## 1.0 Executive Summary

- 1.1 This Technical Note has been prepared by David Tucker Associates (DTA) on behalf of Albion Land, the promoters of Catalyst Bicester within the Bicester 10 employment allocation and adjacent land.

- 2.3 This note responds to the assertion by Oxfordshire County Council (OCC) that the site access still fails to meet the required design principles with respect to providing for cyclists in the context of the climate emergency.

Figure 9 OCC feedback 25/02/20

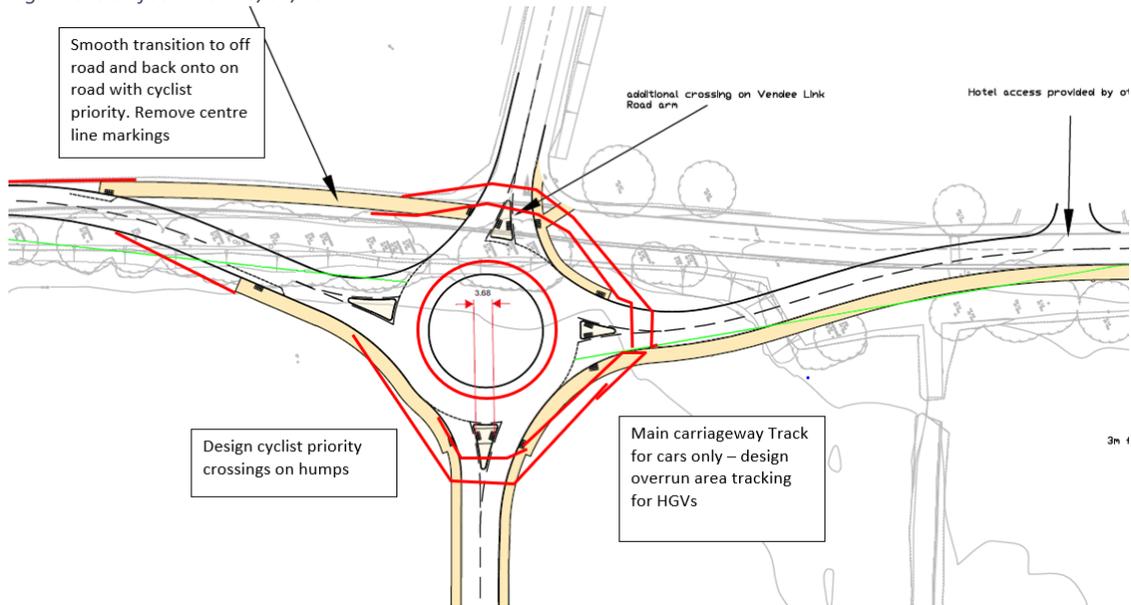
- 7.12 On 18th February 2020, (20 months after liaison started and within 1-2 weeks of their previous set of requests, which had been labelled by them as being “final”) OCC for the first time introduced design requests based on a radically different approach. They provided feedback on the above arrangement noting that the northbound cyclist would be expected to give way 4 times to access the employment site, whereas on road the cyclist would give way just once. In practice it was assumed that a northbound cyclist would cross into the site to the south of the roundabout i.e. also only give way to the modest southbound Wendlebury Road traffic.

- 7.13 A concept sketch for modifications to the design was provided by OCC which is shown on **Figure 8** below. The modifications however bear no relation to the issue identified and present multiple issues with respect to legibility, intervisibility and visibility requirements, path and road alignment and crossing priorities.

- 7.15 To respond to the comments above the scheme was revisited with a view to maximising the safety, convenience and accessibility for cyclists whilst not significantly impacting on pedestrians (**Figure 11**).

Figure 10 OCC compact roundabout with orbital footway and cycleway

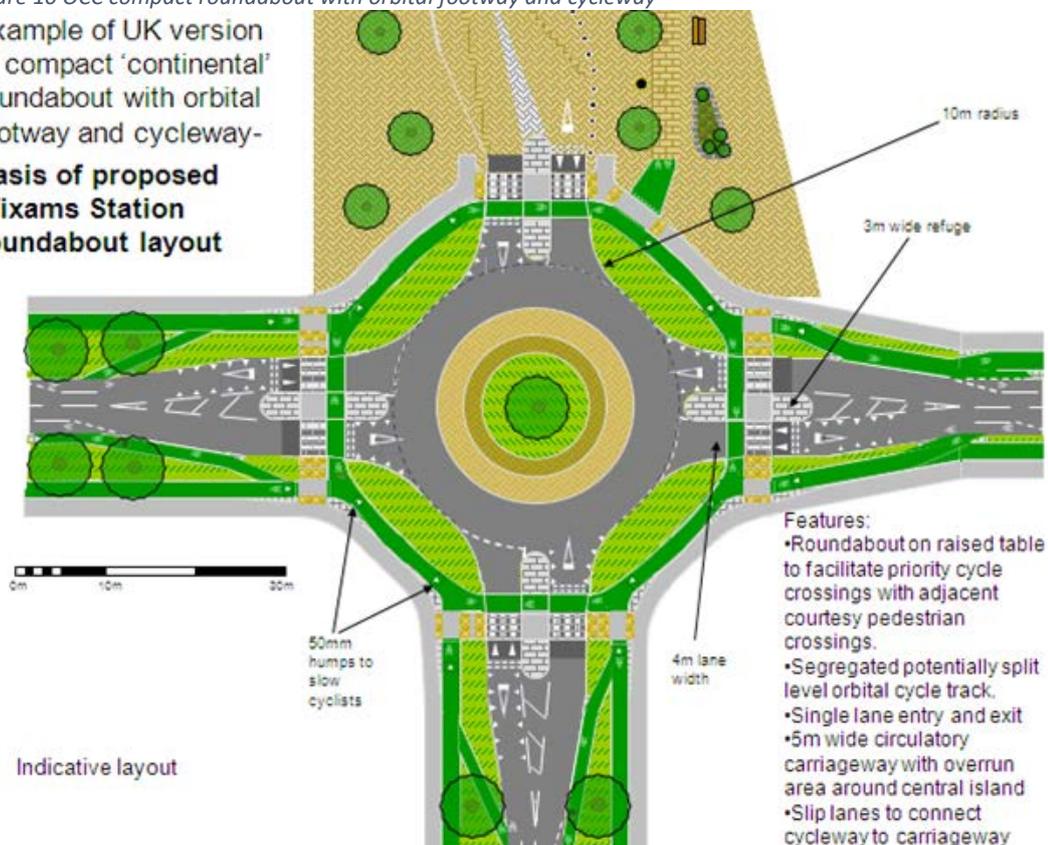
7.14 OCC also provided the diagram included at **Figure 10** below. Whilst badged as an example of UK version of compact ‘continental’ roundabout this too is a concept sketch and has not been implemented. This sketch is however more developed than the sketch in **Figure 9** as it is evident that consideration has been given to appropriate speeds on cycle paths albeit the context for this proposed scheme is clearly very different.

Figure 11 Enhanced cycle provision

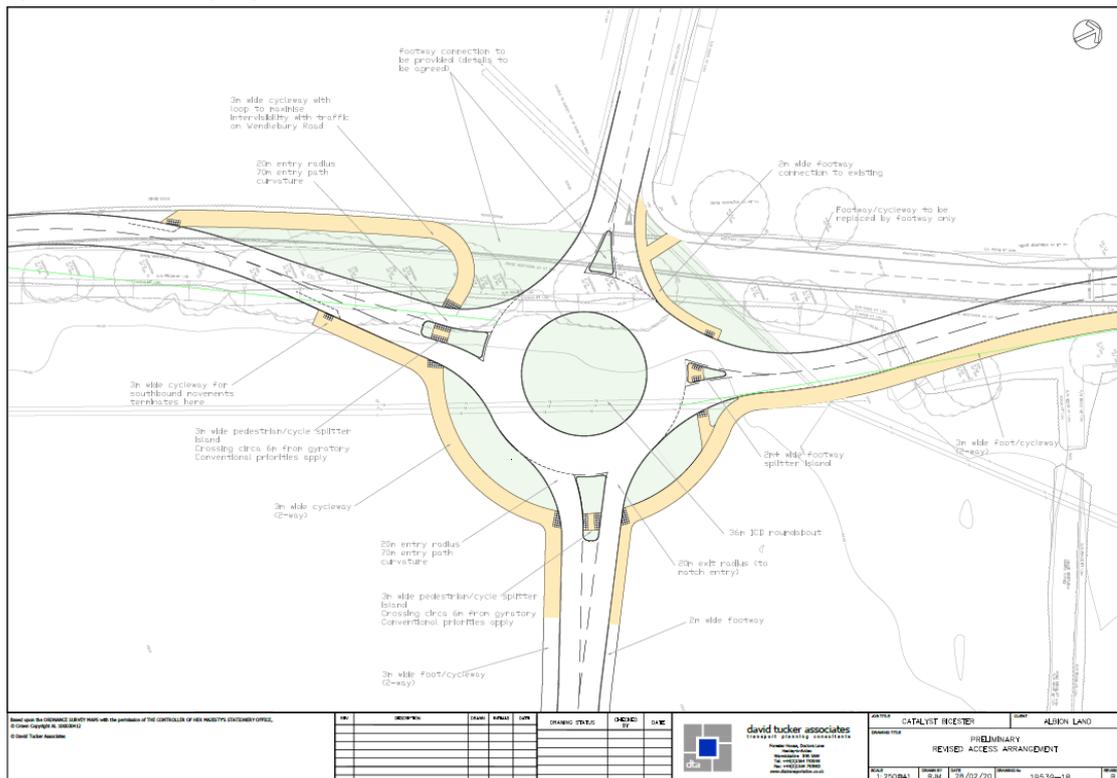
*Summary: Drop at back of footway may present a hazard to pedestrians.*

*A new 3.0m footway / cycleway is proposed along the eastern side of Wendlebury Road, and a new 3.0m cycleway on the western side, south of the proposed roundabout. There is an overgrown ditch running the length of the eastern side of Wendlebury Road throughout the scheme, with a noticeable level difference from the carriageway level to the bottom of the ditch; this is also the case along the western side of carriageway, south of the proposed roundabout. Provision of footway / cycleways at these locations will result in drop at the back of the footway / cycleways, which may present a hazard to pedestrians or cyclists should they leave the paved surface. This may result in falls resulting in personal injury.*

*Summary: Unaccommodated pedestrian desire line may result in trips and falls.*

*A new 3.0m cycleway is to be provided on the south-western side of the new roundabout to allow northbound cyclists to move between the Wendlebury Road carriageway and the new footway / cycleway along the eastern side via an uncontrolled crossing point across the southern arm of the roundabout. An existing footway is present on the northern side of the A41 link road and a footway / cycleway along the western side of Wendlebury Road north of the proposed roundabout that will become footway only. Pedestrians using or intending to use these facilities may attempt to cross the western arm of the roundabout away from*

*any formal crossing facilities increasing the likelihood to trips and falls due to crossing a full height kerb or travelling over unmade ground.*

*Summary: Inappropriate provision of tactile paving.*

*3.0m cycleways are provided on both sides of Wendlebury Road, south of the proposed roundabout to provide appropriately positioned tie-ins between the cycleway and carriageway. At the tie-ins, tactile paving is shown despite no crossing points being present. Pedestrians, particularly those who are visually impaired, may believe there is a crossing point and begin to cross to the other side, increasing their vulnerability of trips and falls, and collision with vehicles.*

- 8.3 This is agreed.

- 8.4 A pedestrian crossing on the Vendee Link Road has been reinstated within the design. This was originally removed on the basis that there would be no pedestrian demand from the southwestern quadrant of the junction, where OCC maintain that there will be no pedestrian permeability into the Bloombridge site from Wendlebury Road, and to aid legibility of the junction layout for cyclists, i.e. route cyclists around the most appropriate route though the junction across to the new cycleway in the northeastern quadrant which minimise potential for conflict with vehicular traffic and with pedestrians. Neither of these have changed. As a compromise it is proposed to sign cyclists as recommended and to provide a pedestrian only link.

- 8.5 The revised design shown in **Figure 13** has been provided to the auditor who considers that the further amendment accords with the content of the Stage 1 Audit of **Figure 11** design.
- 8.6 The details of the tactile and corduroy paving will be amended to align with 'Guidance in the Use of Tactile Paving Surfaces' and to ensure that there is no confusion to pedestrians.

Figure 12 OCC feedback to Figure 10

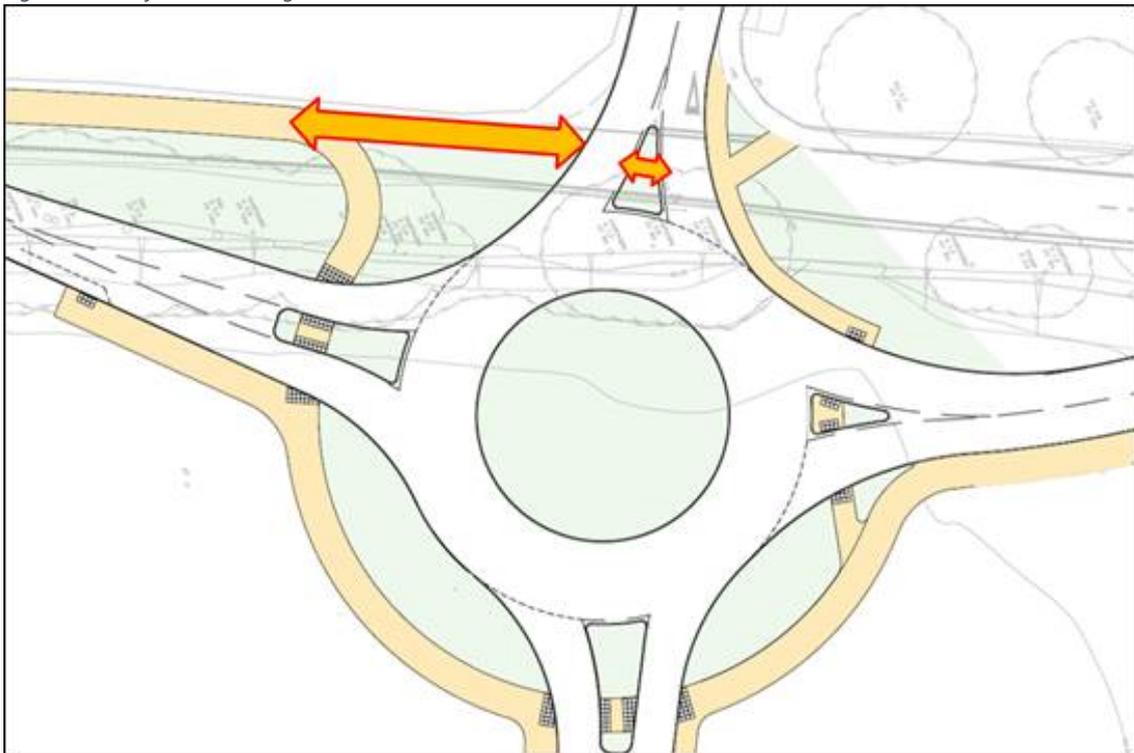
7.21 In response to the redesign, OCC requested that a cycle link be shown across the Vendee Drive Link Road (**Figure 12**). This is considered inappropriate as:

- The provision of this route offers no benefit in terms of journey distance or time;
- The alignment of the cycle path is likely to result in higher speeds by cyclists thereby endangering them as well as pedestrians;
- The alignment of the cycle path results in poor intervisibility with other road users given the angle of approach;
- Visibility on the Vendee Drive Link Road is constrained anyway by the available highway land;
- The route will result in a higher level of potential conflict with other road users given the pattern of movements through the junction.

7.22 This scheme does not provide for pedestrian and cycle priority at the crossing points. This is not warranted on the level of traffic which is too low to generate delays and in practice would offer no benefit to cyclists. If the traffic flows were to materially increase then the layout is capable of being adapted at a later date.

Figure 13 Final access arrangement

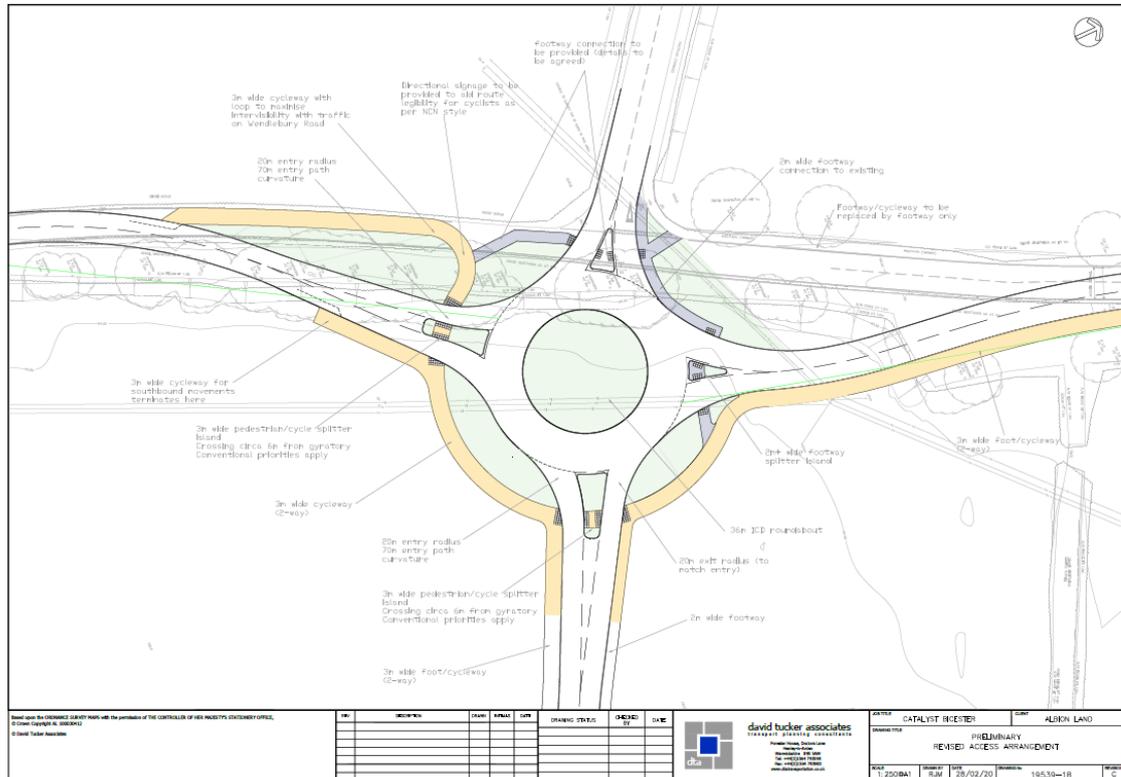
- 8.1 Mott MacDonald was commissioned to undertake an independent road safety audit of the original scheme (**Figure 6**). Although a number of recommendations were made these did not affect the principle of the scheme and were either adopted or would be addressed at the detailed design stage e.g. the need for regrading to the back of cycleway or provision of a safety fence.
- 8.2 With the changes to the scheme Mott MacDonald has undertaken another audit (on the design in **Figure 11**). This is provided under separate cover. The recommendations and designer's responses are set out below.
